**CERTIFICATE OF APPROPRIATENESS**

**Property:** 409 W 13<sup>th</sup> Street, Tracts 17B and 18B, Block 174, Houston Heights Subdivision. The property includes a new 2,482 square foot, two-story wood frame single-family residence with attached garage situated on a 2,867 square foot (47' x 61') interior lot.

**Proposal:** New Construction – Residence-*Revision*

**SOUTH ELEVATION – FRONT FACING W 13<sup>TH</sup> STREET**

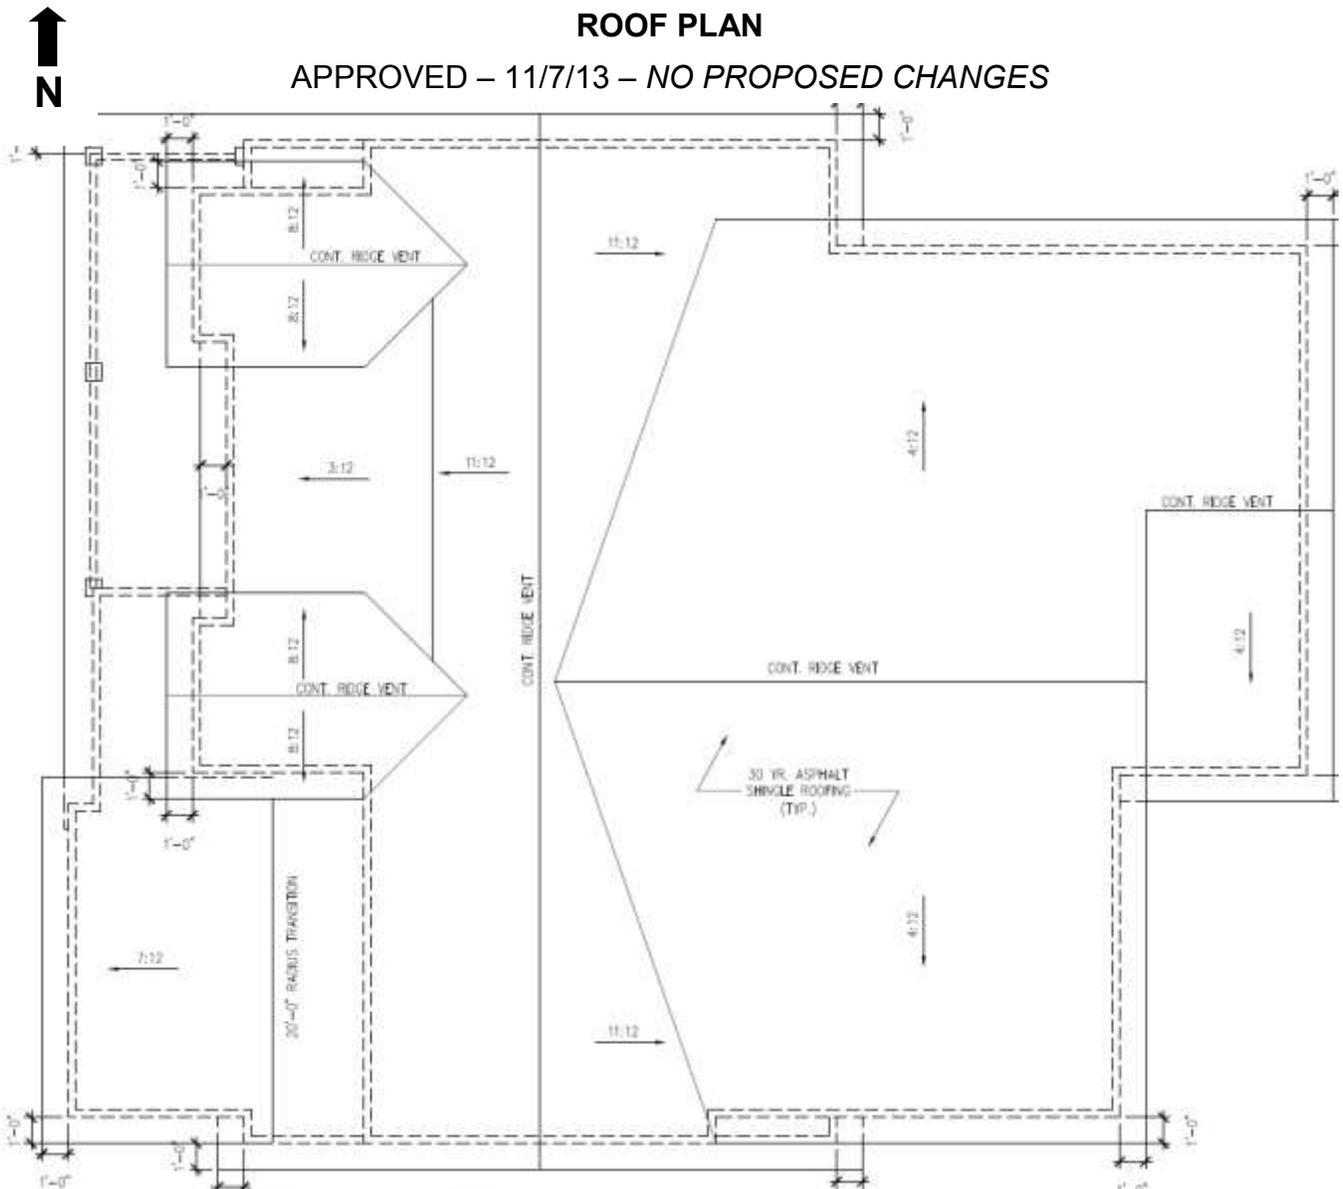
- (1) The new construction must match the typical setbacks of existing contributing structures in the historic district
- (2) The exterior features of new construction must be compatible with the exterior features of existing contributing structures in the historic district  
*The proposed double door front entry is not a compatible feature found on contributing historic residences throughout the district. The originally proposed single lite entry door with single lite side lites is an appropriate entry door as it is a compatible feature of contributing residence in the historic district.*

**Recommendation:** Denial - does not satisfy criterion:2

FIRST FLOOR PLAN

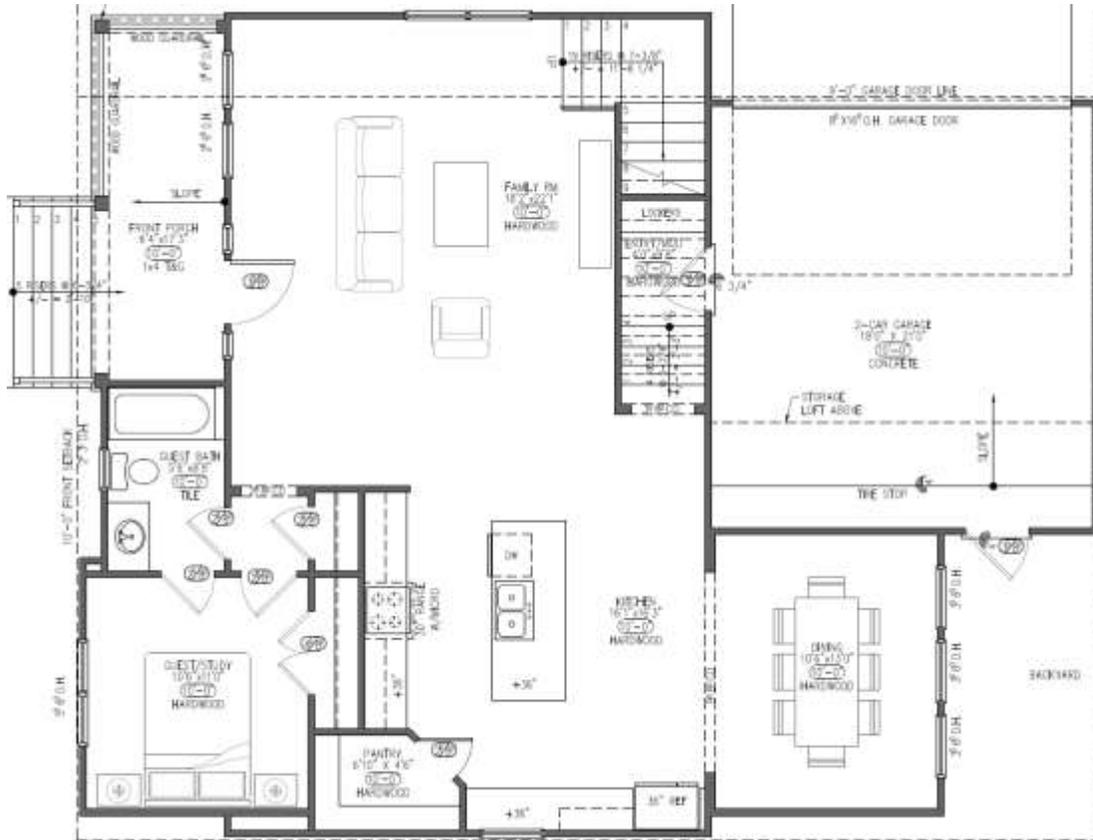
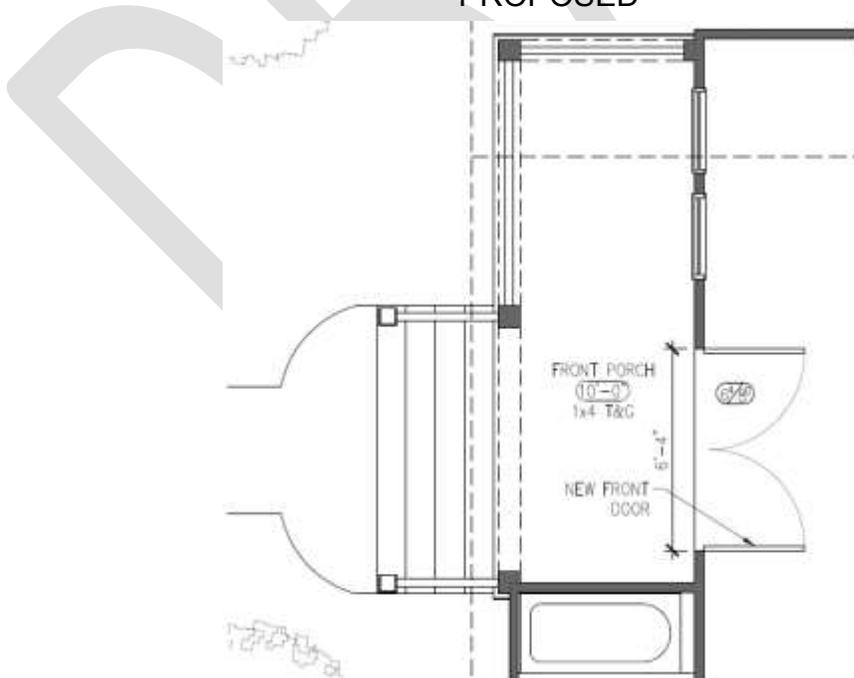
**Windows/Doors:** The proposed residence will feature wood 1-over-1 sash, single lite fixed, and 2 lite casement windows. The residence will feature a **double door front entry made up of two 38", 6-lite wood paneled doors (previously proposed single lite wood paneled entry door with single lite side lites)**, paneled entry door, and sectional overhead garage door. The front entry opening will measure 6'-4" wide.
